PCN no.: <b>PCN-113 rev. 1.2</b>	Date: <b>2019-01-30</b>	
Device affected: <b>nRF52810-QFAA nRF52810-QCAA nRF52810-CAAA</b>	Device version / Build Code: <b>QFAA-Bx0, QCAA-Cx0, CAAA-Ax0</b>	
Data sheet references: <b>N/A</b>	Agreement reference: <b>N/A</b>	Customers reference: <b>N/A</b>

**Description of change:**

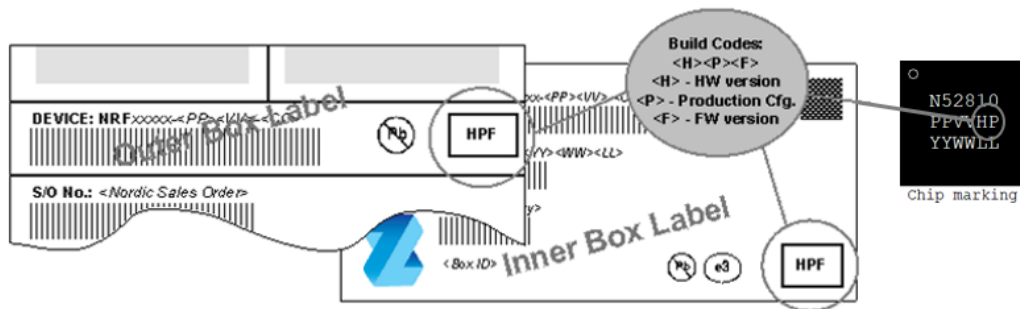
The new device version is software compatible with the current version if using SDK14.2/15.0/15.2 and Softdevices S112 v5.1.0/v6.0.0/6.1.0/6.1.1 or S132v5.1.0, but note that S112 v6.0.0/6.1.0/6.1.1 versions have implemented workarounds for Errata-192 and Errata-201 which will be executed without impact on function on this device version.
